Intel® 845MP/MZ Chipset Platform

Design Guide Update

November 2002

Order Number: 252180-001

Figure 8. THERMTRIP# Circuit Recommendation

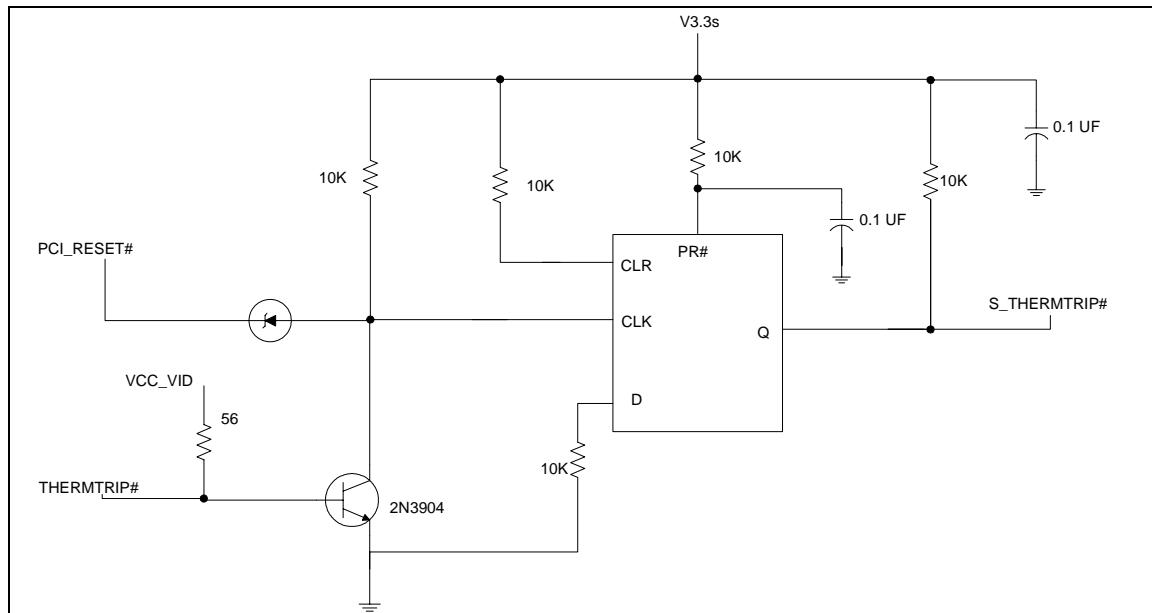
NO.	DOCUMENTATION CHANGES
1	Changed THERMTRIP# circuit design recommendation.

1. Replace section 3.4.4.1 with the following:

3.4.4.1. CPU THERMTRIP# Circuit Recommendation

The following sections describe the topologies and layout recommendations for the miscellaneous signals. In Figure 8, the circuit effectively latches the low state of THERMTRIP# via the D Flip-Flop once the processor has driven THERMTRIP# to a low state. Operation can be restored if the system power is cycled (power off/on system).
